From: **Seaspray Residents Association Ltd** <seasprayra@gmail.com>
Date: Mon, 23 Sept 2024 at 17:57
Subject: Re: AWDM/0423/24 Details Reserved by Condition 8 of Application No AWDM/1906/22 - Objection
To: Louise Prew <louise.prew@adur-worthing.gov.uk>

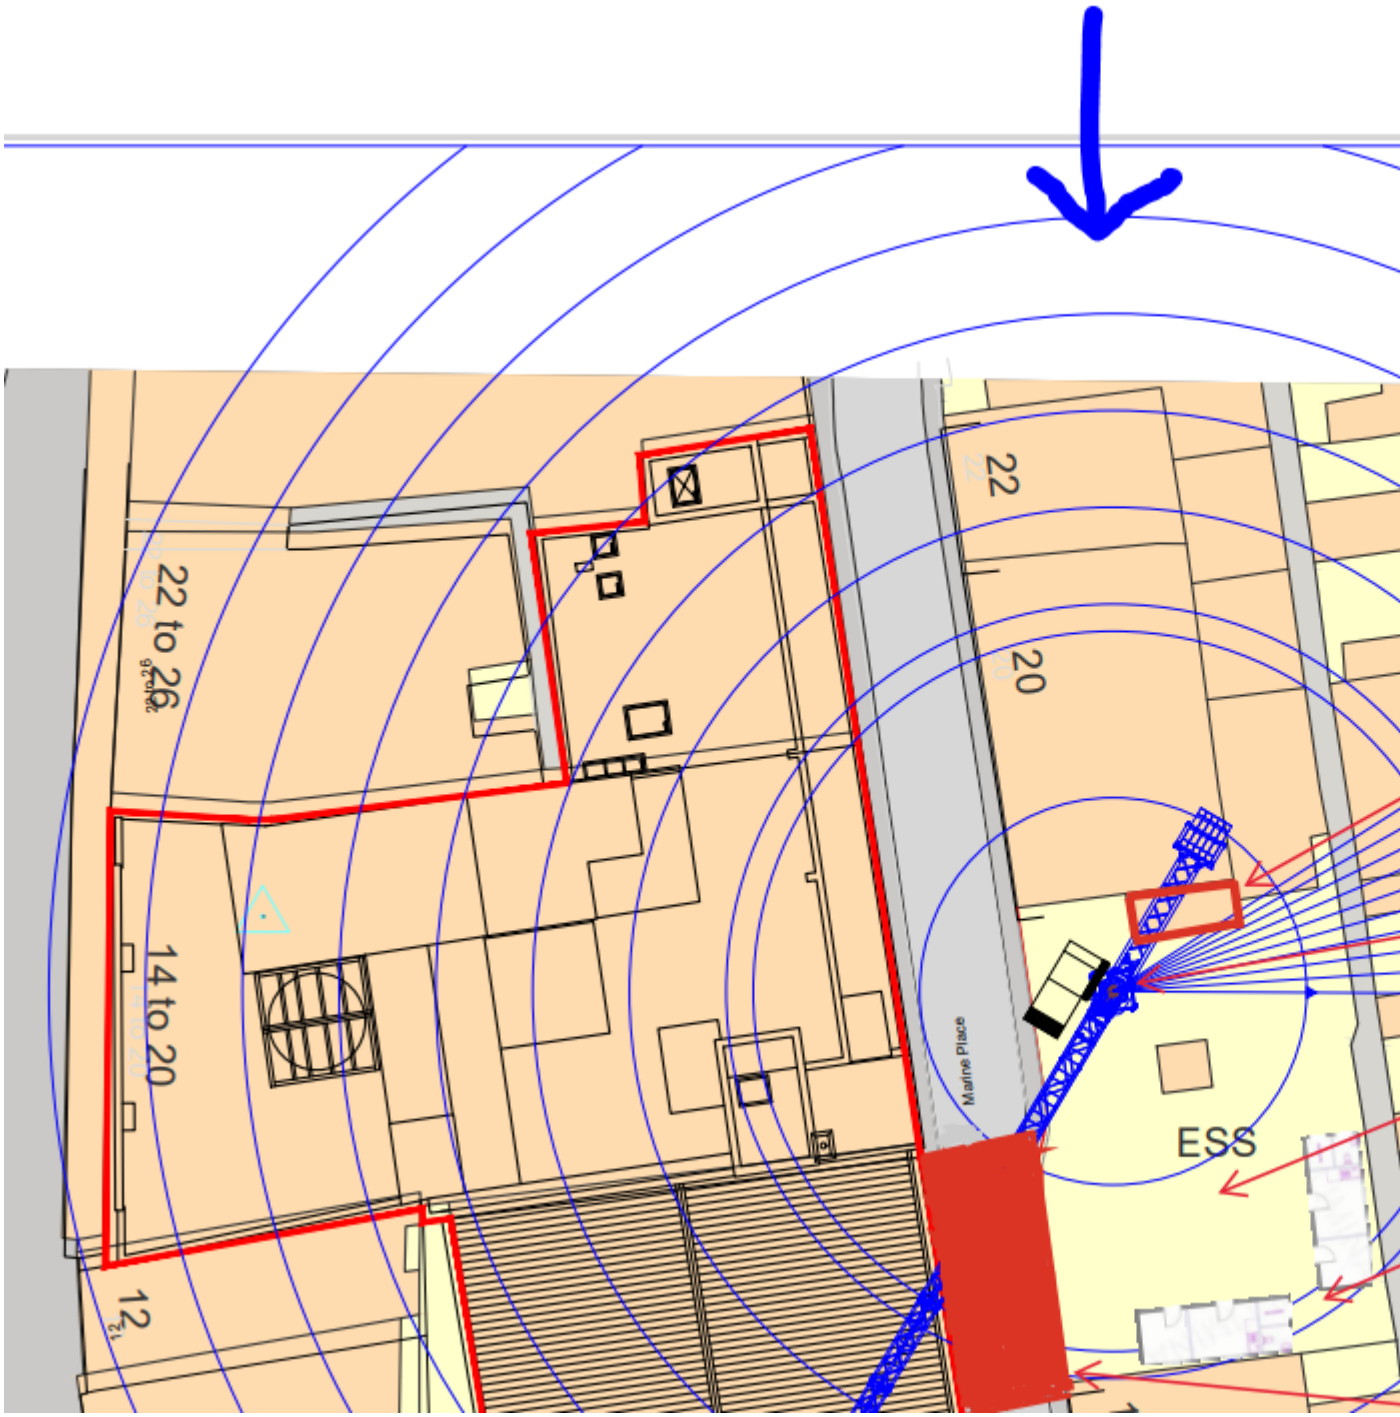
As we have mentioned on the attached, the applicant would be effectively turning the whole area from South Street in the West to the bus garage in the East into a building site with a tower crane oversailing properties on:

Bedford Row
Marine Place
South Street
Marine Parade

For some reason the properties to the north that will be affected by oversailing are not shown on the applicant's diagram. Please see the blue arrow below.

We do not believe that a temporary structure 5m above the highway is a safe proposal either. Objects may fall from this gantry striking members of the public below (who will not be wearing hard hats to walk down the road). Vehicles may strike this gantry and it will be subject to high winds, as will the tower crane.

Temporary structures need Planning Permission and this does not appear to have been applied for. We need more than the red rectangle shown below - we need a structural plan and elevations.
